KMR.CDD.JmQ.1940-1942.01

BUILDING COMPLETION REPORT

AMENDED
PLAN SHOWING PROPOSED FIRST FLOOR
ON PLOT No. 68. SHEET No. J.M.1.
JAMSHED QUARTER
SCALE 8"=1."

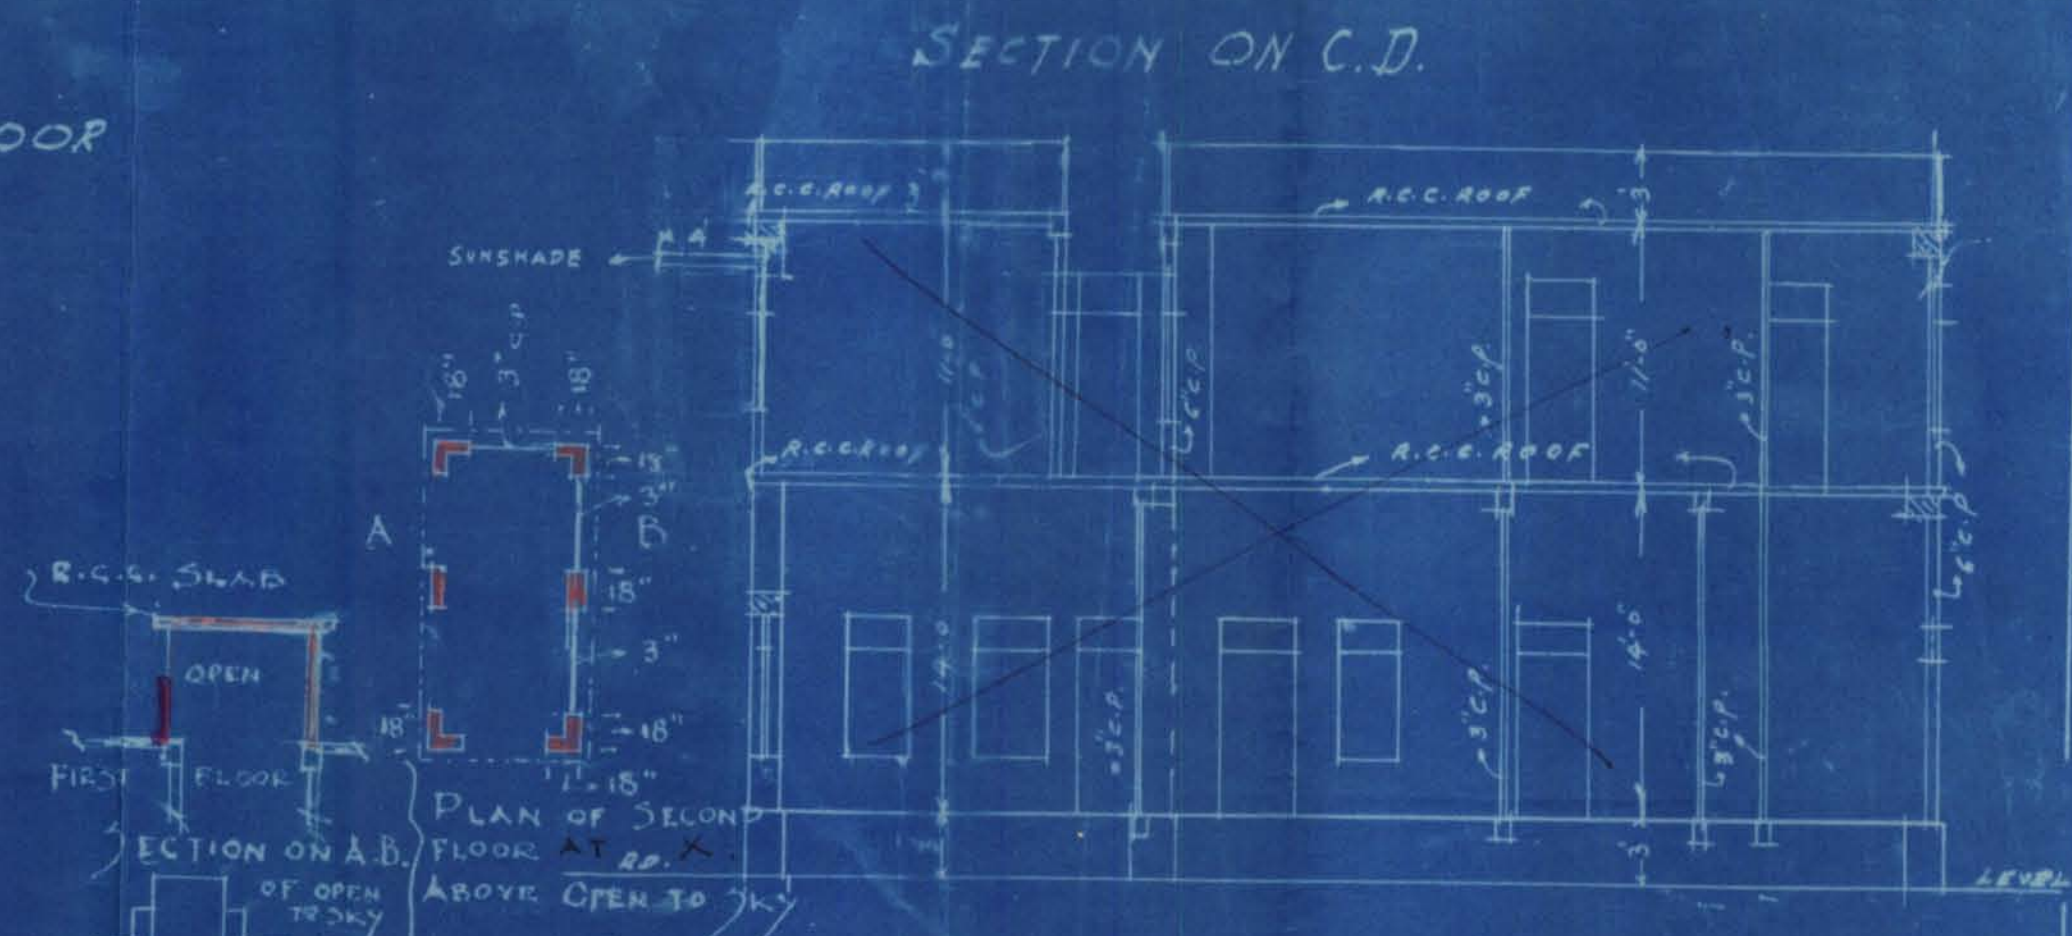
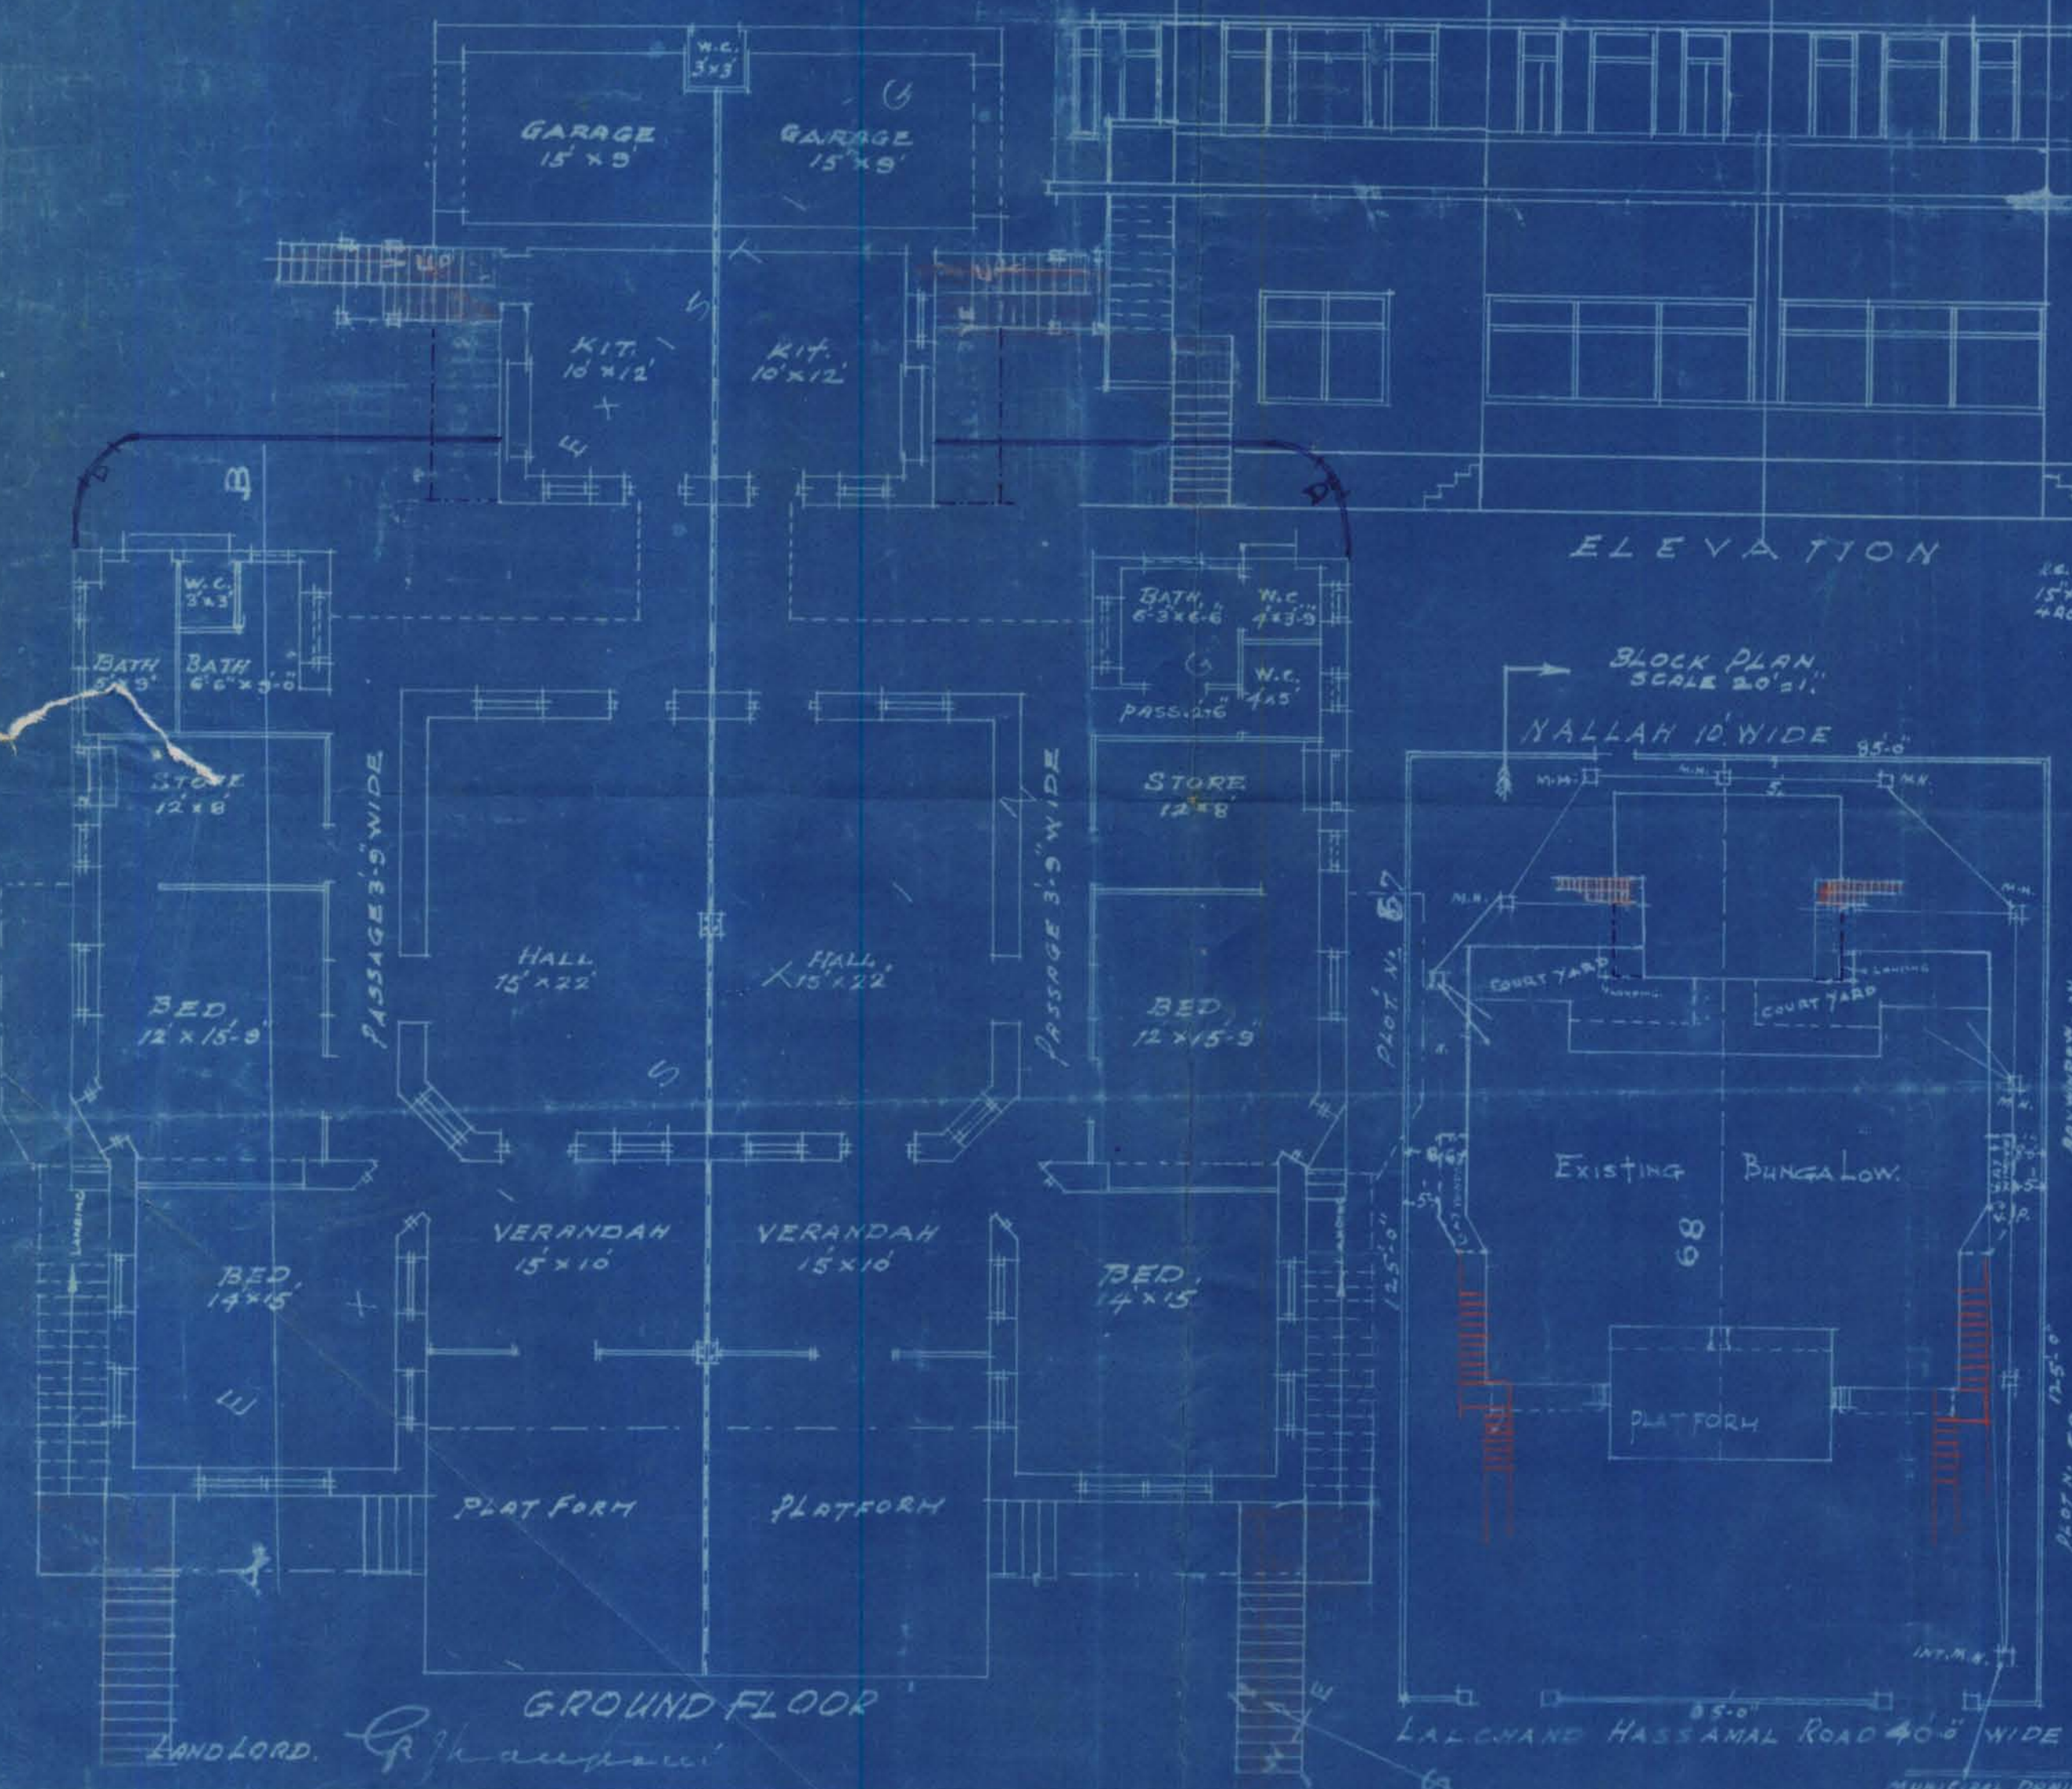
- (1) Coverings over areas which were open to sky to be shown as constructed.
- (2) Balconies to the terrace must be shown together with courtyard. They cannot be allowed in the open area.
- (3) Sink in compulsory open space to be removed.
- (4) Coverings cannot be allowed over the areas originally open to sky cannot be allowed. They also render the central bed rooms dark.

- (1) Coverings over areas which were open to sky to be shown as constructed
- (2) Balconies to the terrace must be shown together with courtyard. They cannot be allowed in open area
- (3) Sink in compulsory open space to be removed
- (4) Submitted.

On the first floor areas open to sky have been covered with roof which is about 8 ft. higher than the general level of ^{the} roof, as shown in the plan. Orders are requested if these coverings be allowed & whether the central Bed-rooms would be permissible.

Objection No. 1. is complied with.

Reg. Objection No. 2. Balconies to the terrace have already been approved in the original approved plan. The only change is that the position of 2'-0" wide stairs has been changed from one side to the other. We might add that in this plot long galleries in the court yard have already been allowed in free area. Court yard wall has been existing since the beginning. It has been shown in the ~~plan~~ plan.

Objection No. 3. Door and roof to the sink have been removed.

Objection No. 4. The covering over the existing open to sky ~~area~~ are intended as a protection from rain ~~in~~ etc.

Besides they are high with the sides open to admit of light and breeze.

The central rooms are not dark. Therefore they may kindly be allowed and plans approved.
